RECEIPT DATE: 6/18/15 **ONSITE SEWAGE DISPOSAL SYSTEM** P 556489
 APPROVAL DATE: 7/21/15 RW **PERMIT: CONSTRUCTION** A _____
 PROPERTY ADDRESS: 815 Iron Rail Court
 SUBDIVISION: Morgan Station LOT: 8 TAX ID: 04-347439
 CONTRACTOR: Fogle's Septic Clean Inc. EMAIL: kevin@foglesinc.com
 CONTRACTOR ADDRESS: 580 Obrecht Road, Sykesville, MD 21784 PHONE: 410-795-5670

RE: BAT Site Plan; Morgan Station Lot 8 (815 Iron Rail Court; Clarke residence)

RE: BAT Site Plan comments; Morgan Station Lot 8 (815 Iron Rail Court; Clarke residence)

MORGAN STATION
 LOT 8
 SITE PLAN FOR BAT INSTALLATION

CUSTOM PLAN - SITE PLAN
 LOT 8

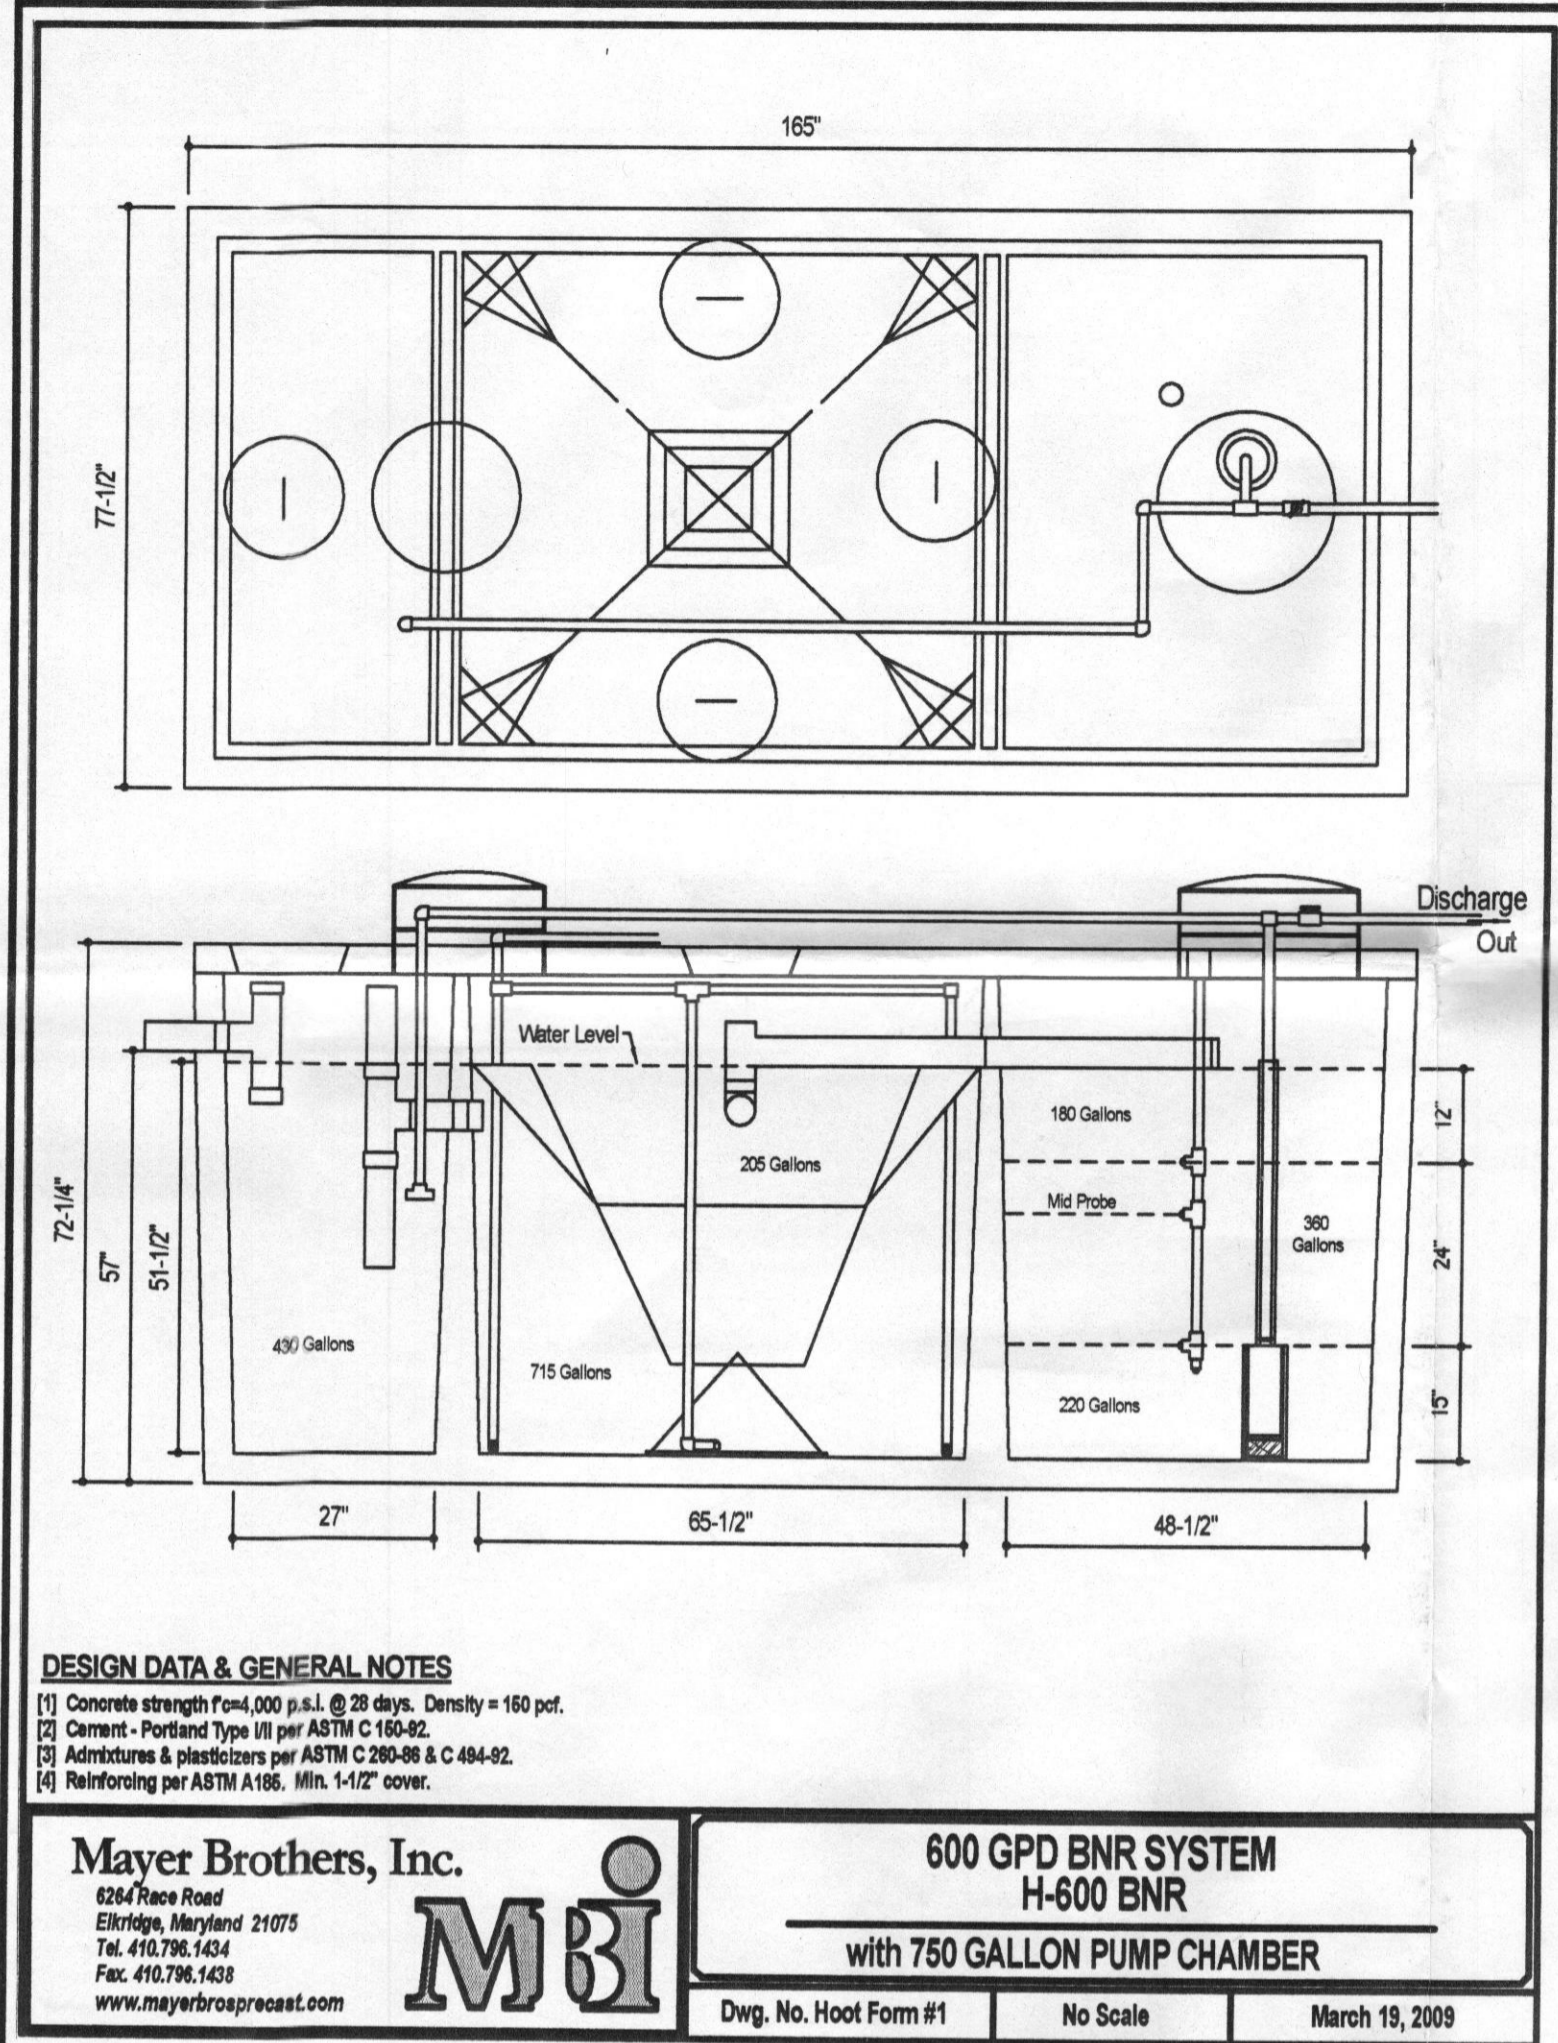
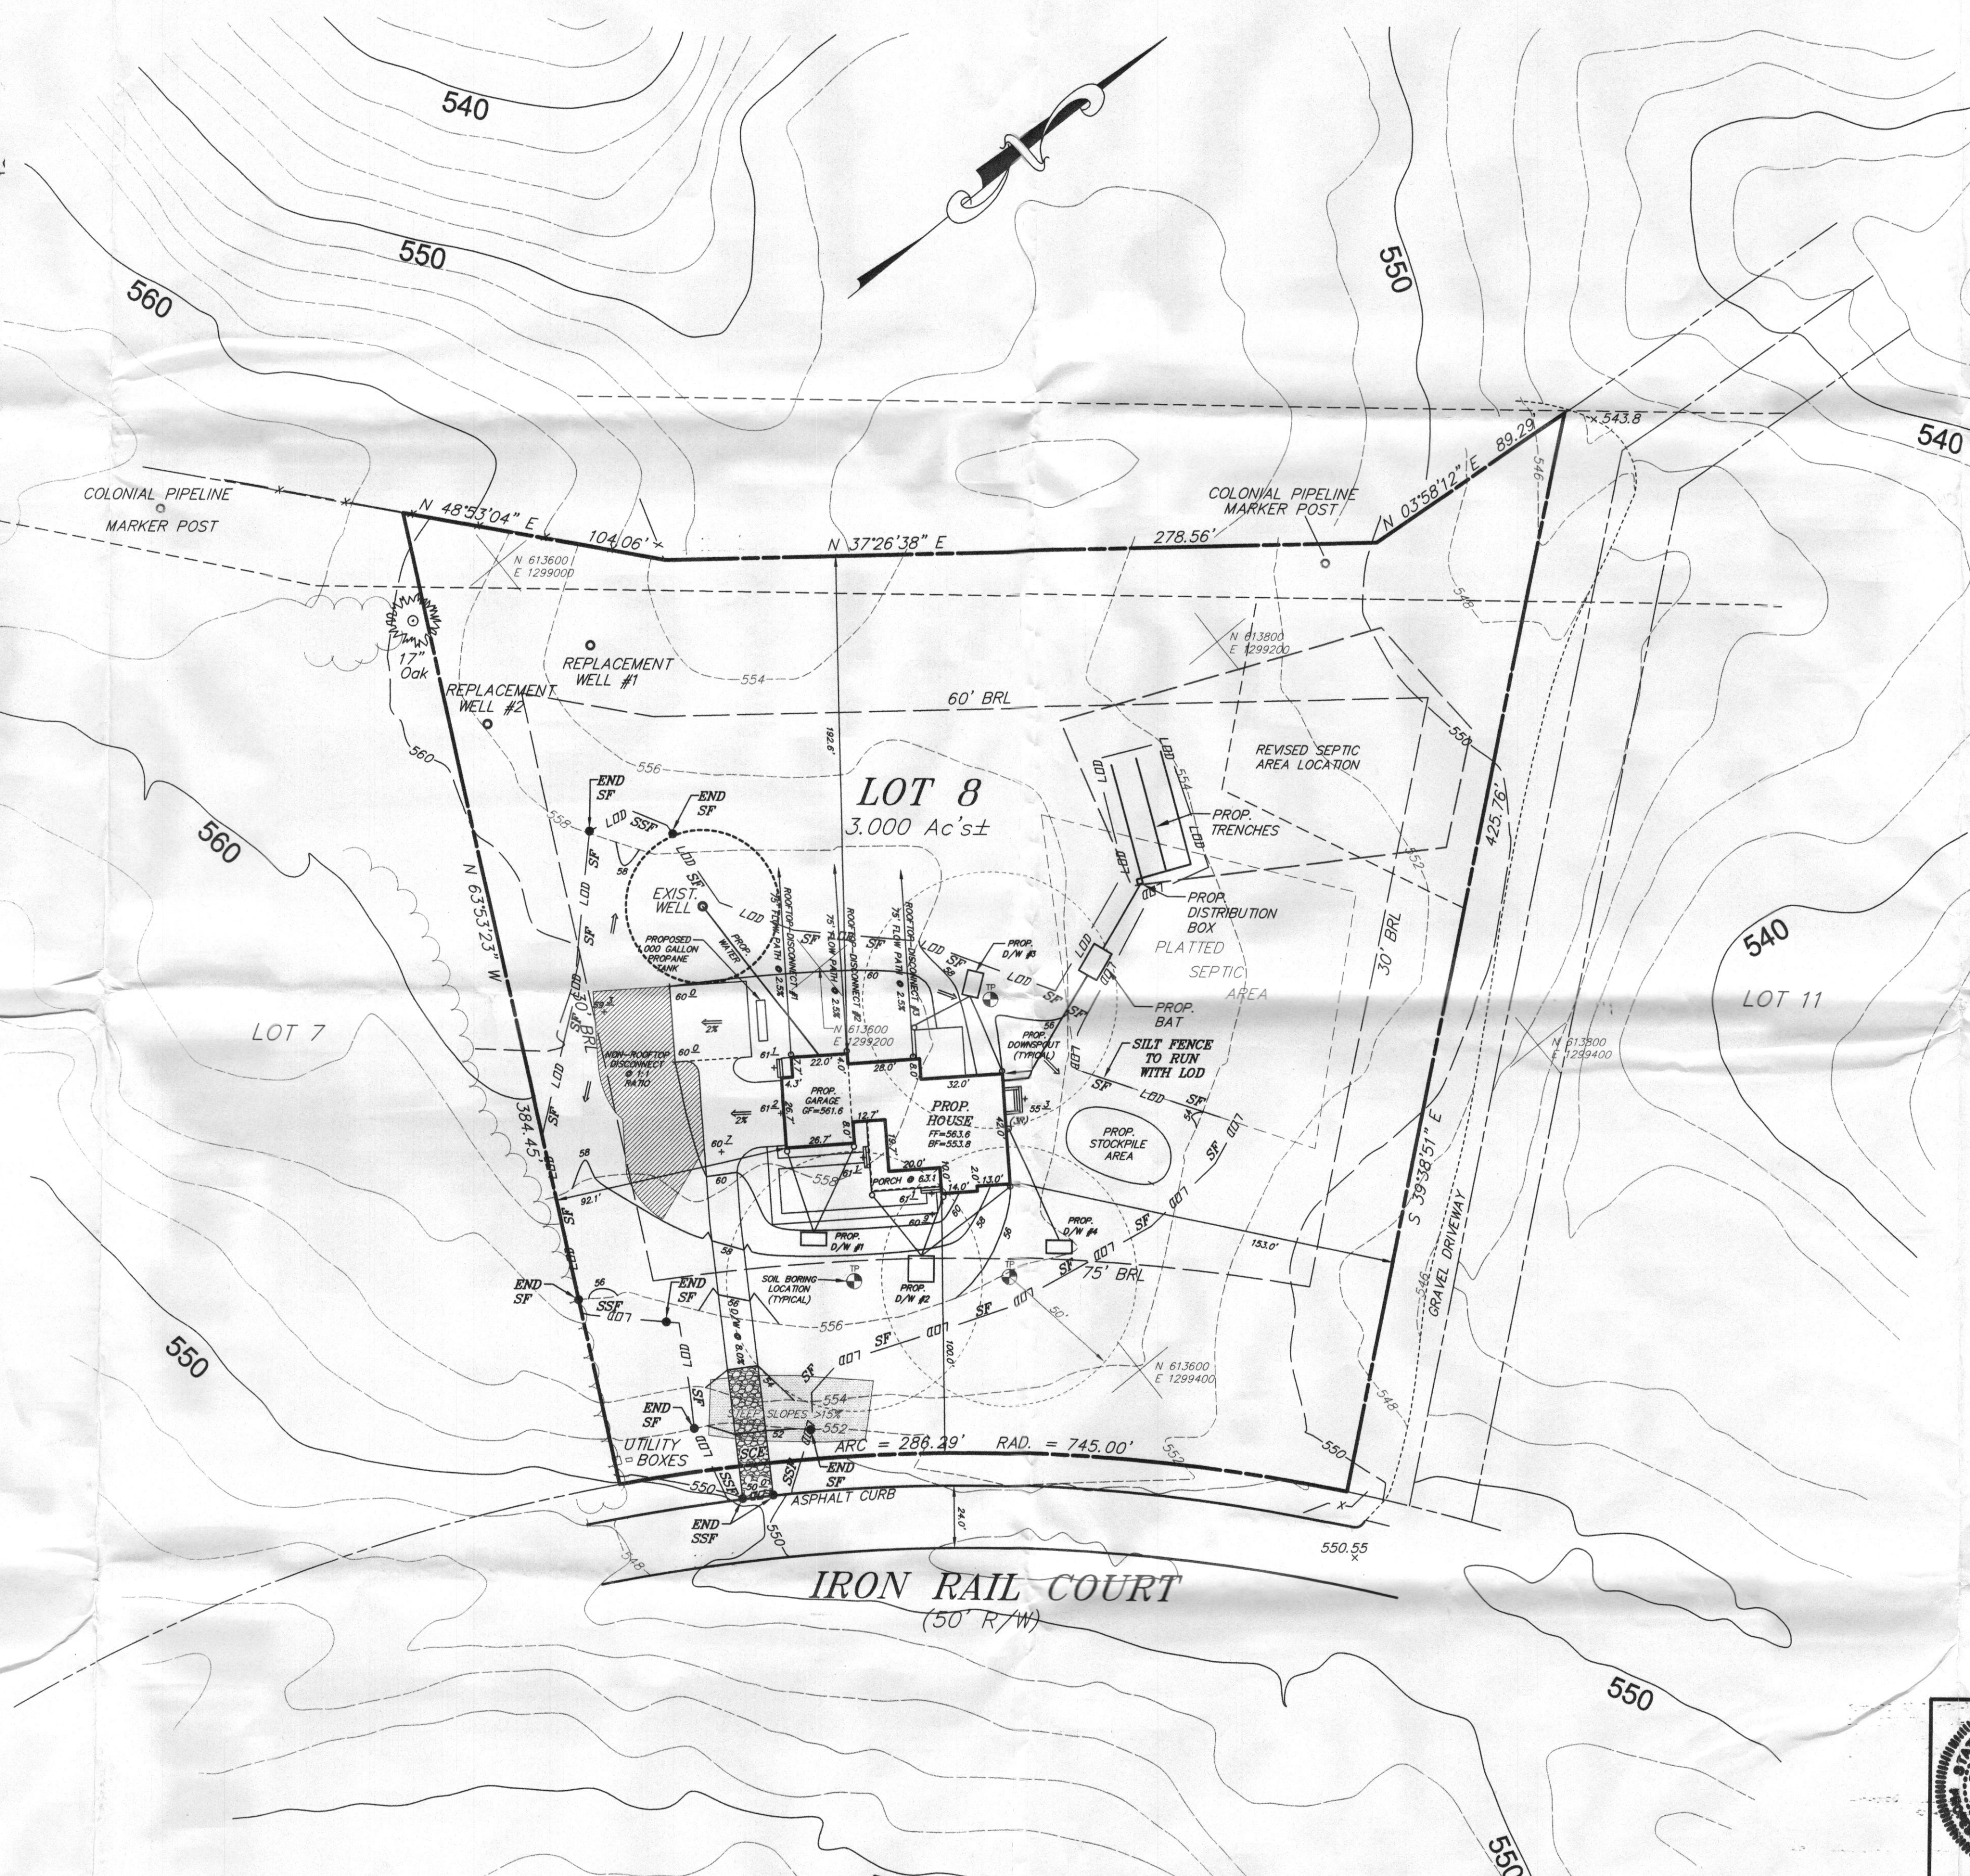
The plan received here on February 23, the Grading Plan, does not include all of the information required for approval of the ^{OSDS design} proposal by the Health Department. Please see attachment named 'BAT_plan_requirements_12-6-2012' for required content of the BAT Site Plan. All of the content described in this document must be represented on the plan submitted to the Health Department. I have noticed that the septic system drainfield you've proposed is too compact and the spacing between trenches is too narrow. As a result, the area you've defined within the "LOD" is too small to accommodate a properly designed drainfield. The full width of the upper septic reserve area needs to be available for installation of properly designed trenches.
